Cranwood

**Construction
Environmental
Management Plan**

Report Ref.	CBE2050/C/CEMP/202304-EC
Rev.	C
Issue Purpose	Planning Condition 19
Assessor	Edward Coate
Signature	
Approved By	Ryan Thrower
Date of Issue	18 th October 2022
Date of Revision	24 th April 2023

Haringey Council have reviewed the initial issue of the CEMP and provided comments (see below). The sections relevant to these comments are also as below. Some comments are also carried over from the associated DEMP:

Figure 6.2: Site Map with Access Points (Construction)

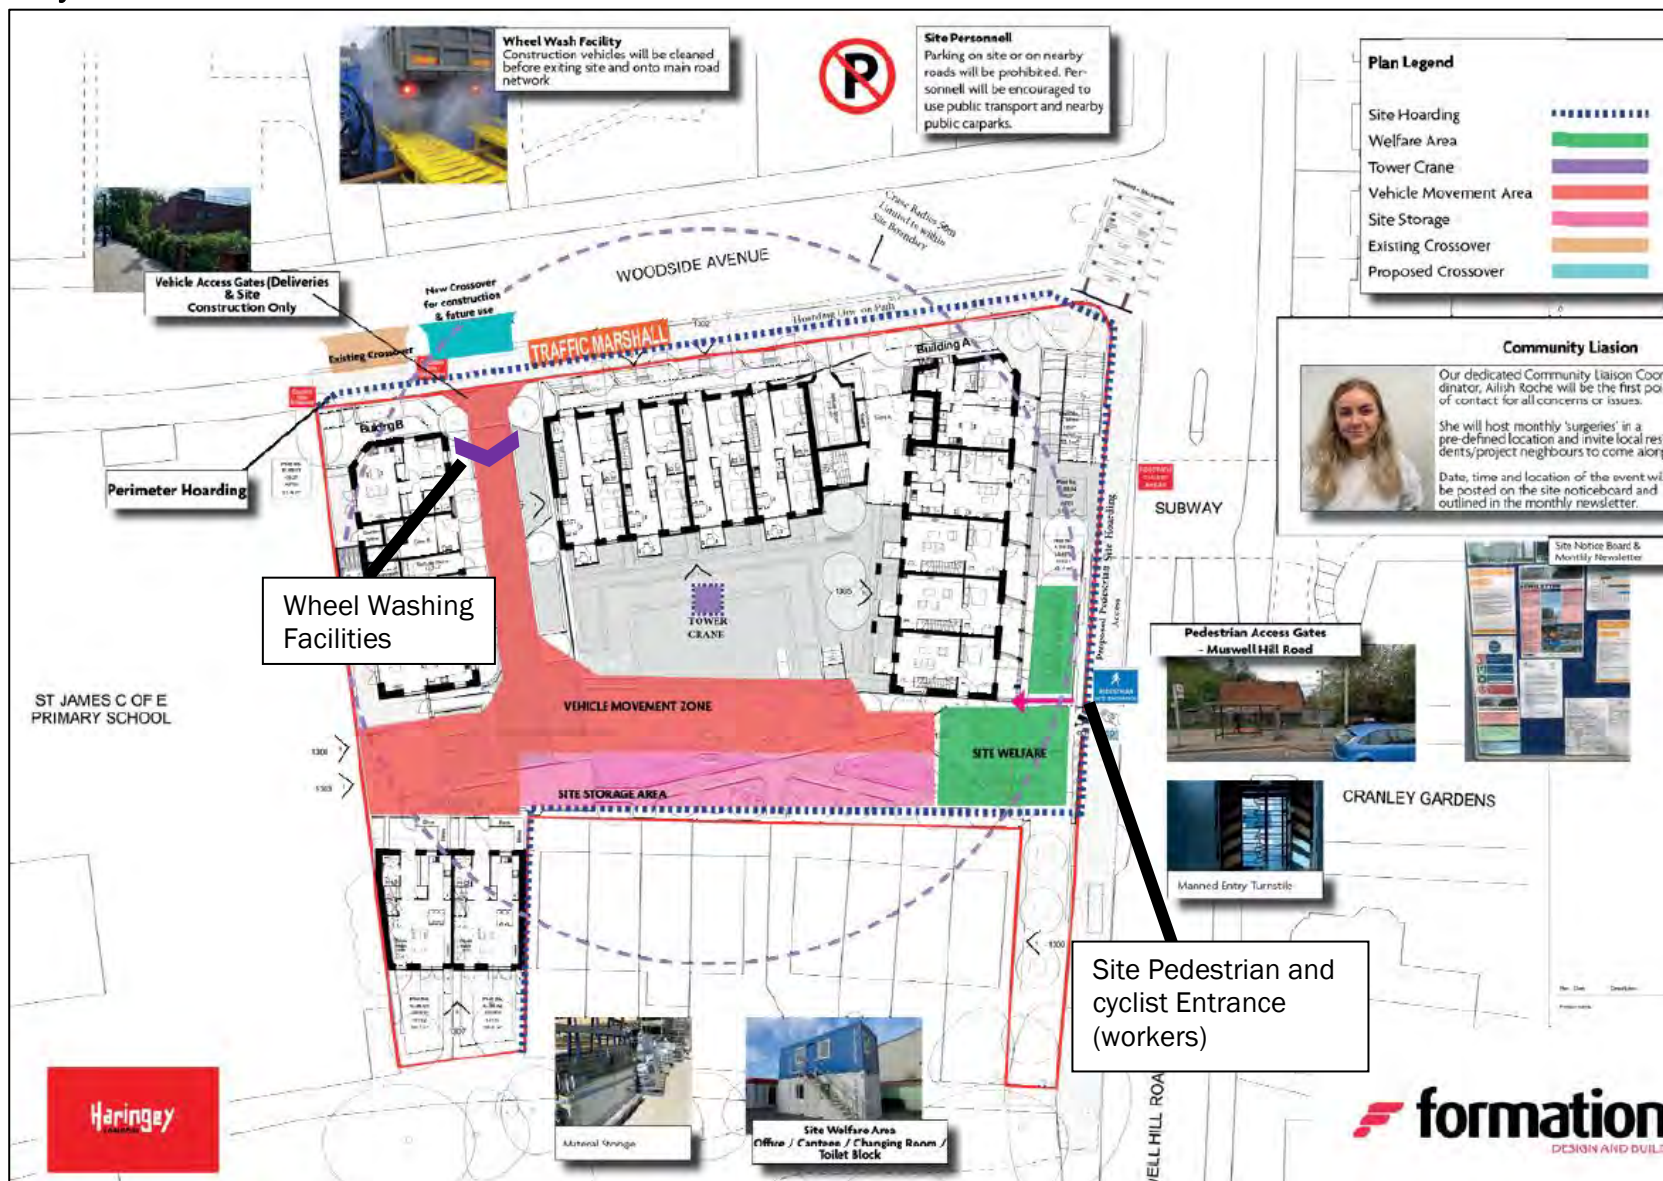
It isn't clear on the logistics drawing where pedestrian and cycle access will be into the site. For the Demolition phase it is shown indicatively next to the existing crossover.	Figure 6.2 and Section 7.0.

Finally with respect to access, the arrangements for the wheel wash should be clarified and detailed. There is reference on the site logistics plan but no detail of the location or space requirement and how it will be accommodated at the access.	Section 4.0.
There is reference to no on site parking being available for operatives/staff working at the site. The logistics plan details that parking on local roads by workforce and staff will be prohibited. Most of the streets in the locality are not covered by a CPZ so this cannot be enforced or implemented.	Section 7.11.
There is no reference to the set up/use of a travel plan nor the measures to be used to encourage sustainable travel by workers or visitors to the construction site.	Section 7.3.
There should be details provided of the numbers of workers attending site during the build, and the measures that will be employed to promote walking, cycling and public transport. This will need to include details of sufficient cycle parking and associated showers/lockers and the like to encourage this.	Section 7.4.

Wheel wash facilities will be used on site and can be seen on Figure 6.2. Formation will ensure that there will be no run off of arisings/water back to Highway drainage.

- Carry out visual dust monitoring daily at pre-determined air quality monitoring locations, to manage the generation of dust. If elevated levels of dust are measured during groundwork and construction periods of the development, site activity will be halted, and any issue resolved or sufficiently mitigated
- A committed wheel washing area will be established near the site entrance and can be seen on Figure 6.2.

Figure 7.1(a): Construction Vehicle Access

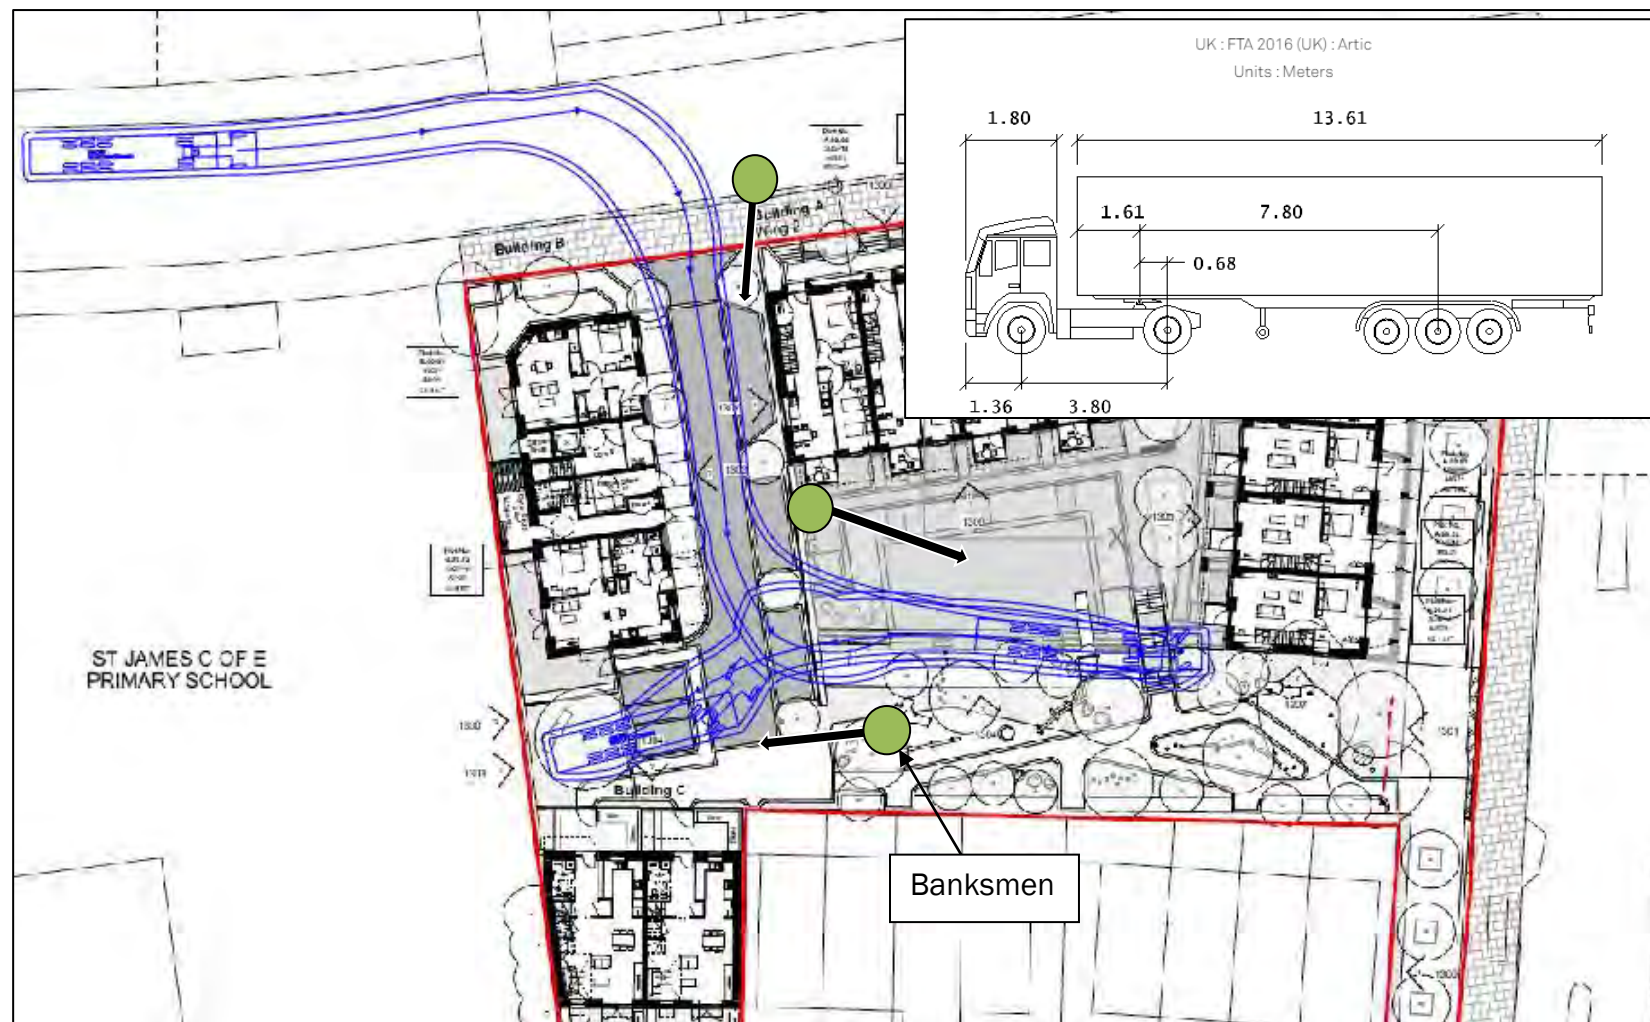
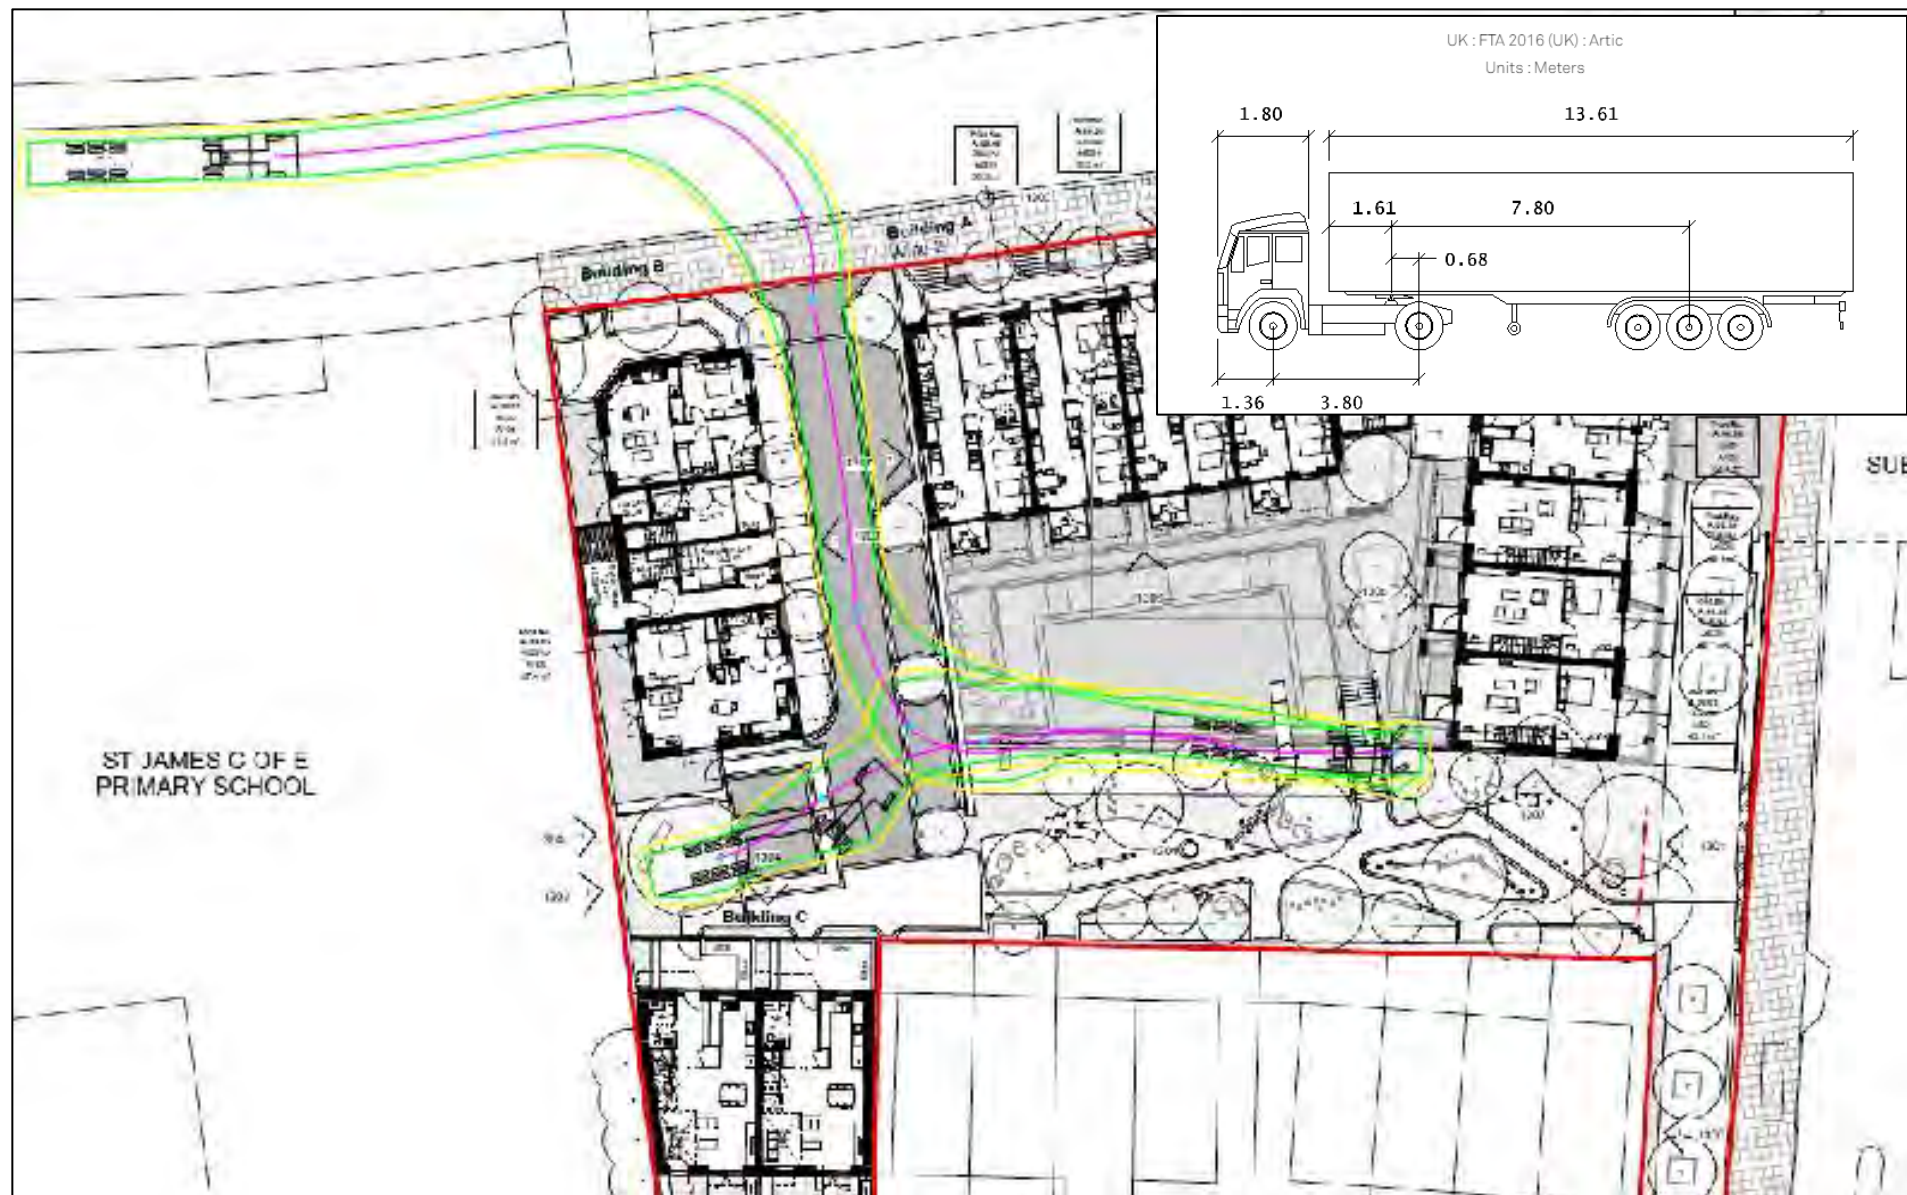
Transportation Comment	Section / Response
With respect to the arrival and departures of construction related vehicles, there is reference to avoidance of the peak hours (0700 – 0900 and 1600 – 1800) on page 6. It is however very strongly suggested that the period within which vehicles arrivals and departures are restricted to should be changed to between 0930 and 1500, as movements by pedestrians, parents and the like with the adjacent school are likely to happen beyond 0900 and before 1600. As commented in this response with respect to the DEMP, it is very strongly suggested that the period within which vehicles arrivals and departures are restricted to should be changed to between 0930 and 1500, as movements by pedestrians, parents and the like with the adjacent school are likely to happen beyond 0900 and before 1600.	Section 2.3.
In addition to the above, there should be a detailed commentary on how vehicles will be overseen and managed when making manoeuvres into and out of the site to and from the public highway, to ensure a safe approach is taken. This commentary should detail how many accredited and qualified banksmen are utilised and describe how movements will be managed for the different sized vehicles, including management of both vehicles and pedestrians/cyclists using the public highway.	Section 7.0. Figures 7.1- 7.2.

Vehicles will pull into site in forward gear, and then slight left inside site, keeping inside the demarcated loading and vehicle movement area (see Figure 6.2). These larger vehicles will then reverse to the western perimeter of the site, inside the site's area, to ensure they can then swing left out of site without hindrance. This specific movement can be seen on Figure 7.1a and b.

During entry, these 3 banksmen can be seen on Figure 7.1a. During egress, these 3 banksmen can be seen on Figure 7.2a. These banksmen's potential movements during access and egress can also be seen on these Figures as they will not remain stationary during vehicle movement.
